PETITION #2019-039
MALLARD CREEK NEIGHBORHOOD
CHARLOTTE, NORTH CAROLINA
DEPENDABLE DEVELOPMENT, INC.

RZ-1

Rezoning Transportation Analysis

Petition Number: 2019-039

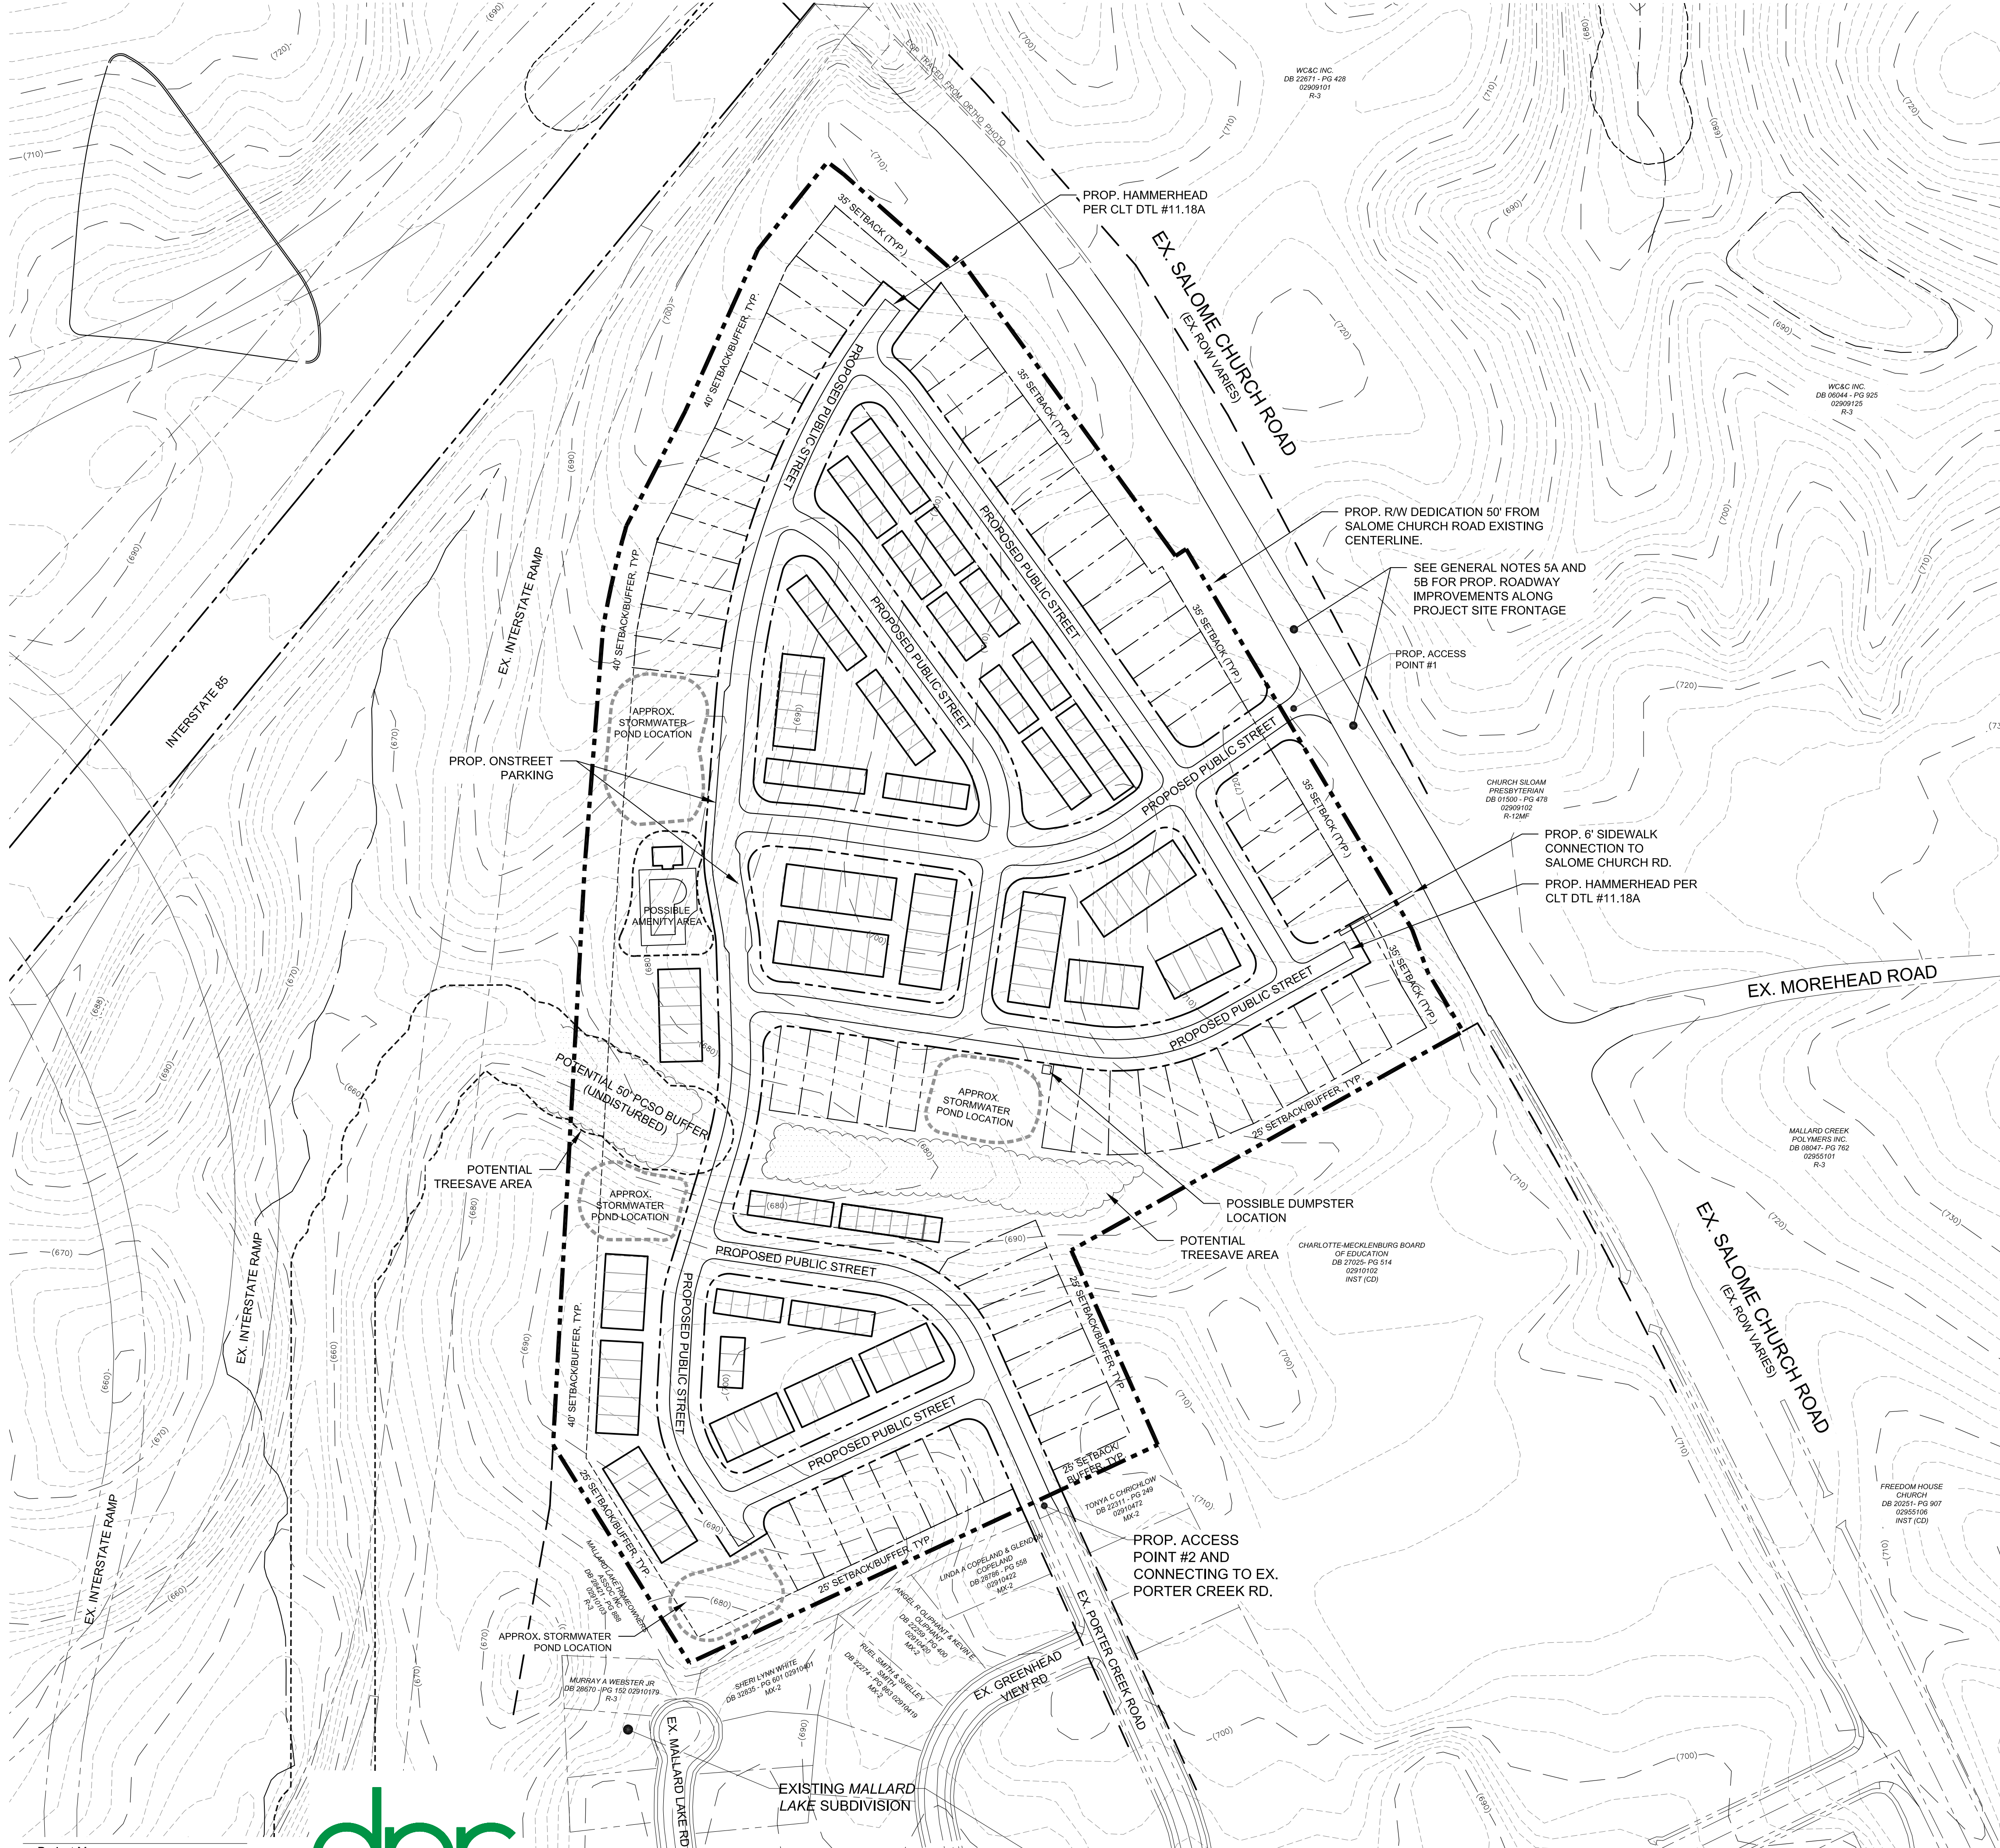
1. **Curbline:** The proposed zoning district has a setback measured from back of the existing or proposed future right-of-way line. The location of the future back-of-curb for:

- Salome Church Road – 30 feet as measured from the road's existing centerline. The petitioner should update the site plan to commit to construct the curb and gutter at the location mentioned above. The site plan should label and dimension the curb and gutter from the road centerline.

2. ~~**Traffic Study:** A Traffic Impact Study is not necessary for the complete review of this petition.~~
3. The petitioner should revise the site plan and conditional note(s) to specify and implement a 12' multi-use path, 8' planting strip, and 2.5' curb and gutter along the site's Salome Church Road frontage and extending to the I-85 bridge.

5. **Comment revised.** The petitioner should revise the site plan and conditional note(s) to commit to ~~asymmetric~~ **symmetric** off-site roadway improvements, to provide two 11' wide southbound travel lanes, **one north bound travel lane**, and a northbound 11' left turn lane on Salome Church Rd. at the proposed access location. The left turn lane should provide 100' of storage capacity and a 100' bay taper.

DPR Response: Done. See revised Note. We added "asymmetric or symmetric" per our agreement at the meeting w/ Rick, Eric.
6. ~~The petitioner should revise the site plan and conditional note(s) to include the proposed public street connection to existing Porter Creek Road.~~
7. **Comment revised.** The petitioner should ~~revise the site plan and conditional note(s) to specify and provide an 8' planting strip and (6') 8' sidewalk throughout the entire subdivision. Also, the 8' planting strips and (6') sidewalks along the site's proposed southern public street need to be extend to Salome Church Rd's 12' multi-use path. This pedestrian connection will provide a direct pedestrian/bike connection to Salome Church Rd. and provide pedestrian access to Stoney Creek Elementary.~~

DPR Response: Done. See revised Note.
8. ~~The petitioner should revise the site plan to add a note specifying dedication and fee simple conveyance of all rights of way to the City before the site's first building certificate of occupancy is issued. CDOT requests a sidewalk utility easement at 2' behind back-of-sidewalk.~~
9. **New Comment:** The petitioner should revise the site plan's note 5.B, to specify that **all transportation improvements will be approved and constructed before the site's first building certificate of occupancy is issued.**

DPR Response: Done. See revised Note. CDOT & Petitioner agreed on 40th Building CO.
10. ~~The petitioner should revise site plan note 5D to state the petitioner commits to implementing traffic calming measures, including three (3) speed humps, stop signs, and 25 mph speed limit signs within the subdivision. These devices will be funded by the petitioner and their placement will be determined during the permitting process.~~
11. ~~The petitioner should revise the site plan to implement on-street recessed parking on both sides of the proposed public street that fronts the possible amenity area. Accessible on-street parking spaces should also be provided on both sides of the proposed public street.~~
